Subject: Request for Modification of the Phased Section 404 Individual Permit and Section 401 Individual Water Quality Certification, Neuse River Riparian Buffer Authorization for the construction of the Triangle Expressway Southeast Extension from NC-55 Bypass in Apex to I-40, Wake and Johnston Counties. TIP Nos. R-2721, R-2828, and R-2829. Debit \$570.00 from WBS 35516.1.TA1.

This letter is a request for a modification to the R-2828 section of the Complete 540 project that will add impacts at Site 41 for a realignment and restoration of Stream SCY. Due to recent storms, it appears the stream section behind the noise wall has eroded and is at risk of losing the bank, which would impact the stability of the noise wall and the ditch behind it.

WETLAND AND SURFACE WATER IMPACTS PERMIT

BUFFER IMPACTS PACKAGE

PERMIT DRAWING
SHEET 92 OF 171

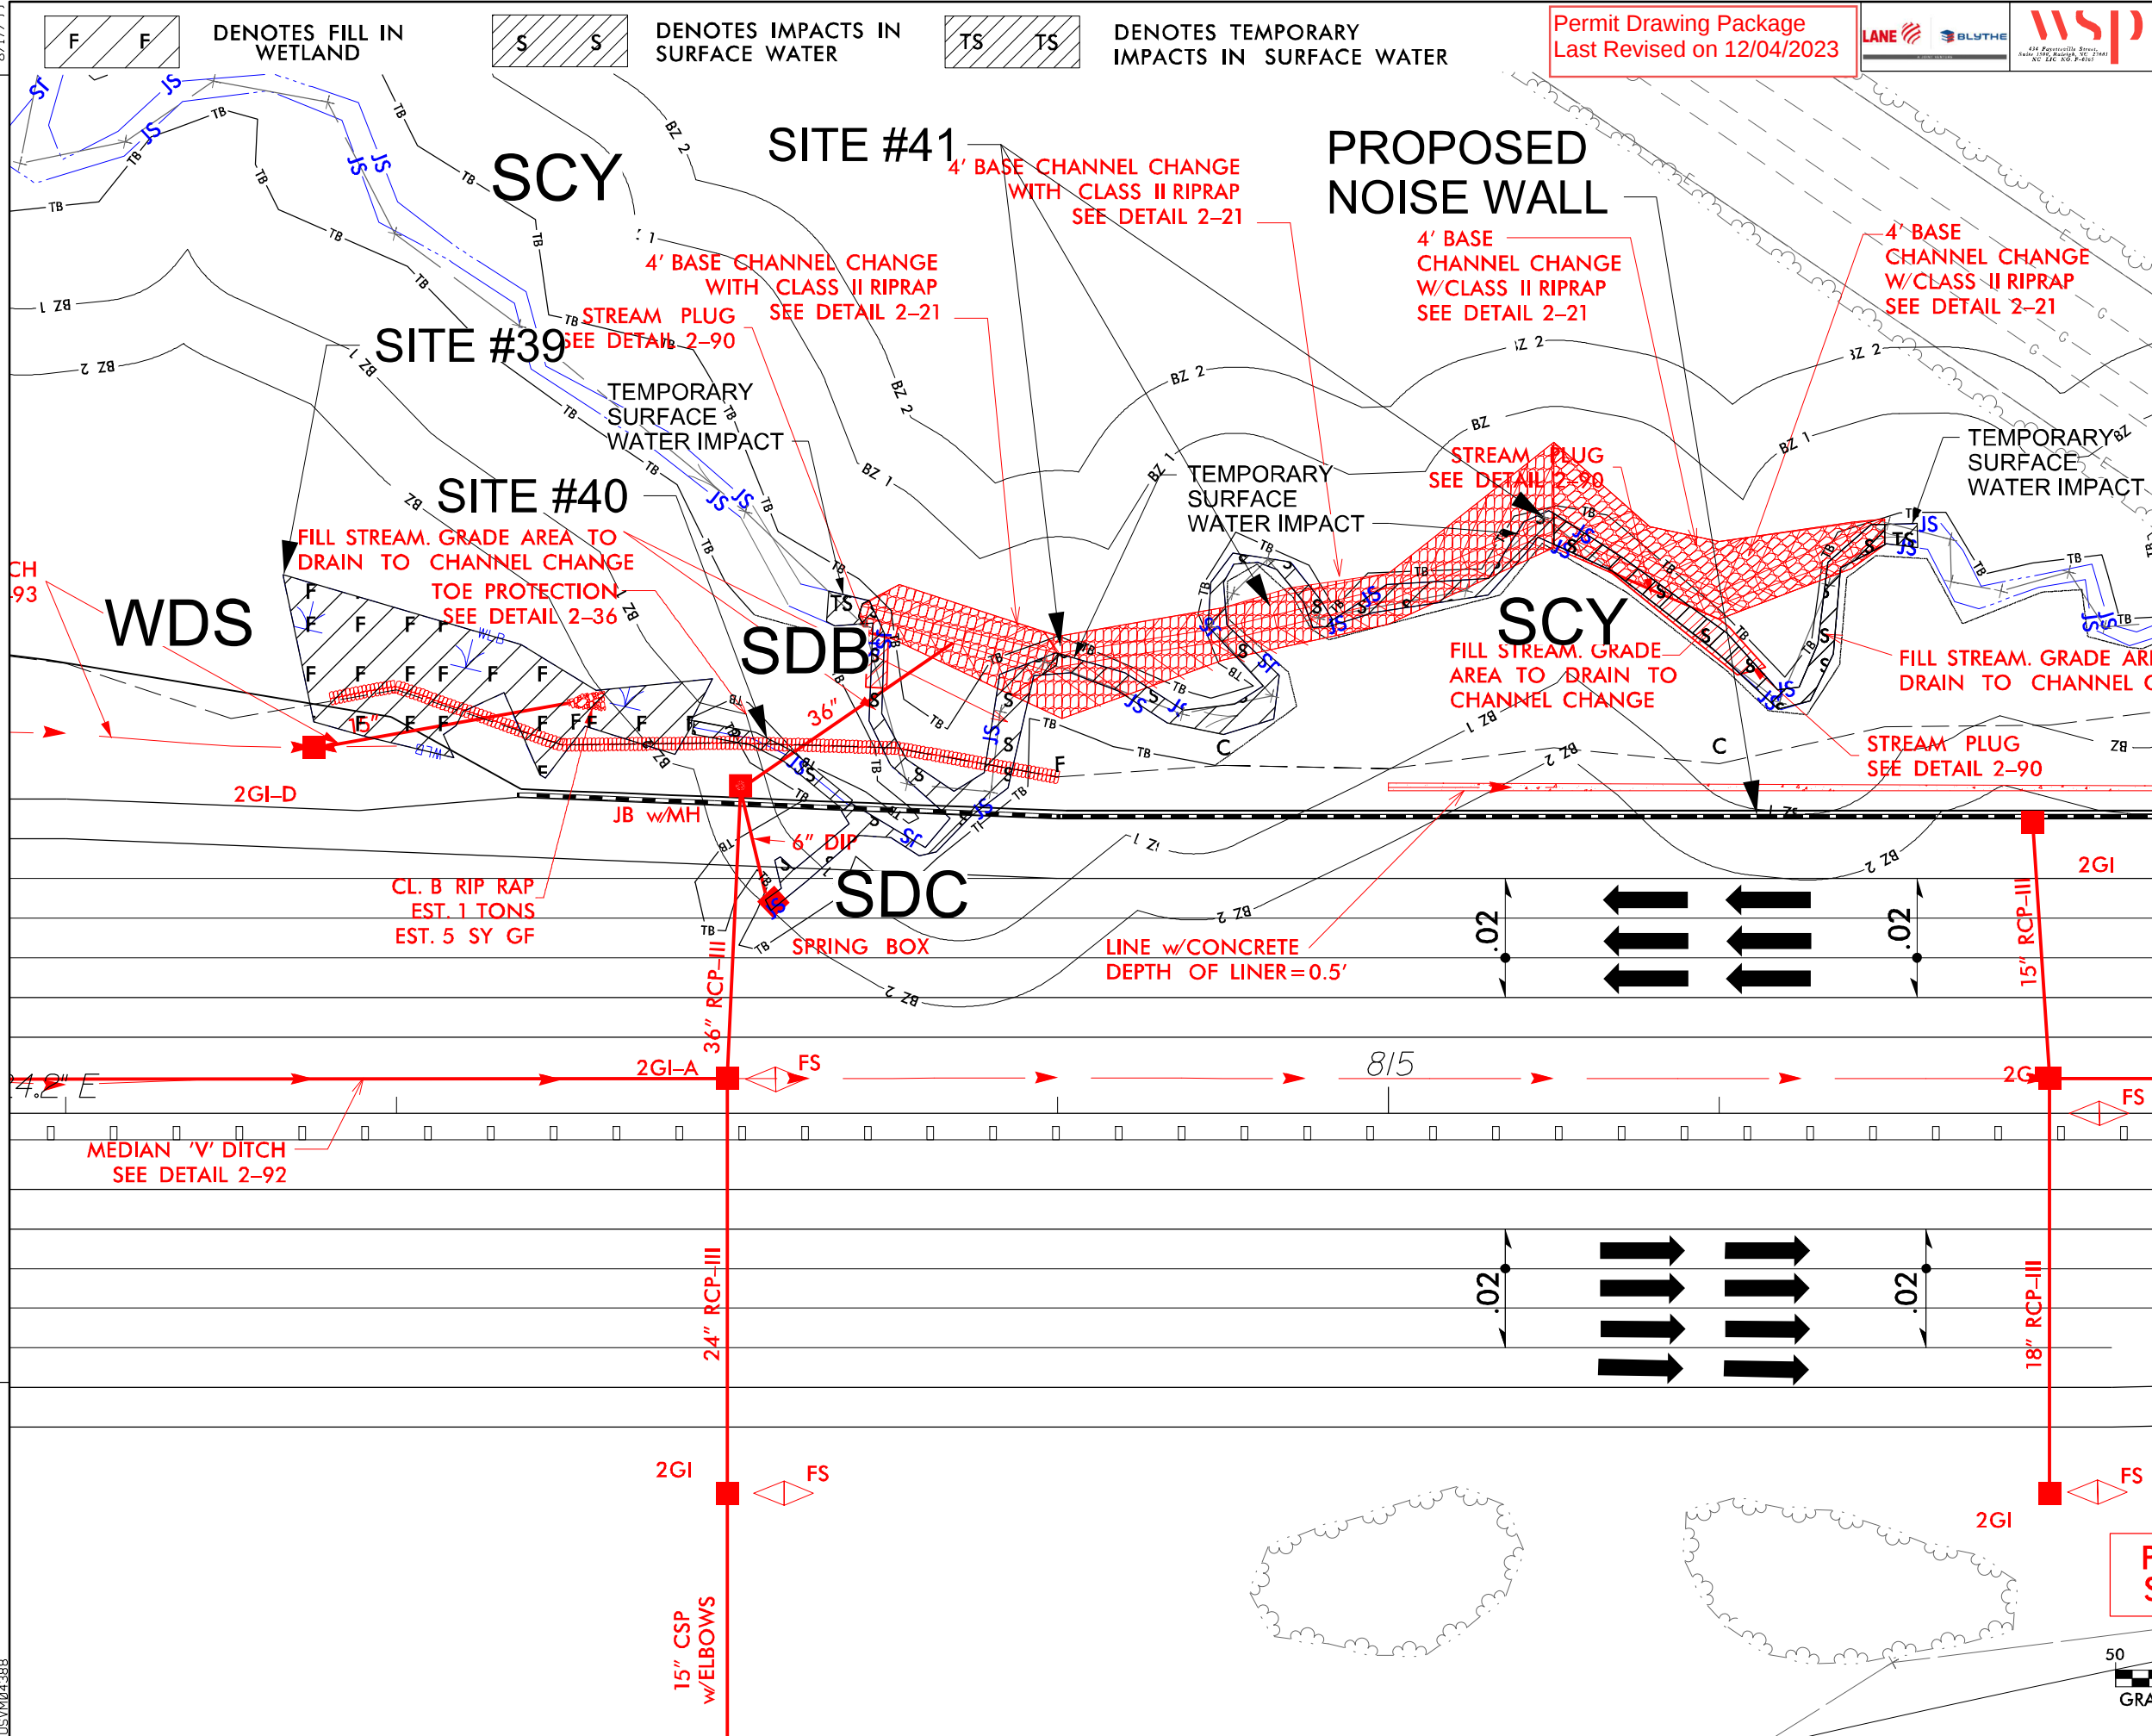
The stream channel (SCY) at Site 41 located at STA 814+00 to 815+00 -L- Lt has become deeply incised with failing and unstable banks in close proximity to the proposed noise wall and ditchline location. Alternatives considered included adding additional bank stabilization to the failing banks or utilizing natural channel design to relocate the channel away from the future noise wall and ditchline. It was determined that bank stabilization was not feasible as the existing banks are nearly vertical and approximately 15-feet in height. Bank stabilization would also not address or eliminate the conflict with the long-term stability and durability of the future noise wall and ditchline, as well as the potential safety issues for maintenance of both structures, which will be immediately adjacent to the steep and failing banks. Relocating the channel away from the area of scour was determined to not be practical as the natural topography would require extensive clearing and excavation into the hillside in order to create a stable channel. Additionally, there is not enough room between the existing sections of rip rap lined channel relocation to adequately design a functioning natural channel with appropriate pattern, dimension and profile.

Therefore, the alternative chosen is to connect the two existing sections of rip rap lined channel relocation with an additional section of rip rap lined channel. This modification will effectively control the sheer forces within this channel, manage and protect downstream water quality, while also preventing any continued bank failures, which could jeopardize the noise wall and the permanent ditchline structures.

- Permit Site 41 (Permit Drawing 90, 91, 92, and 93 of 171, Plan Sheet 24 and 24A)
 - Permanent stream impacts:
 - Increase of 0.03 acre of permanent surface water impacts.
 - Increase of 236 linear feet of permanent surface water impacts.
- Buffer Site 41 (Buffer Drawing 16 of 42, Plan Sheet 24)
 - Riparian buffer impacts
 - Increase of 7,887 square feet of buffer zone 1 impacts
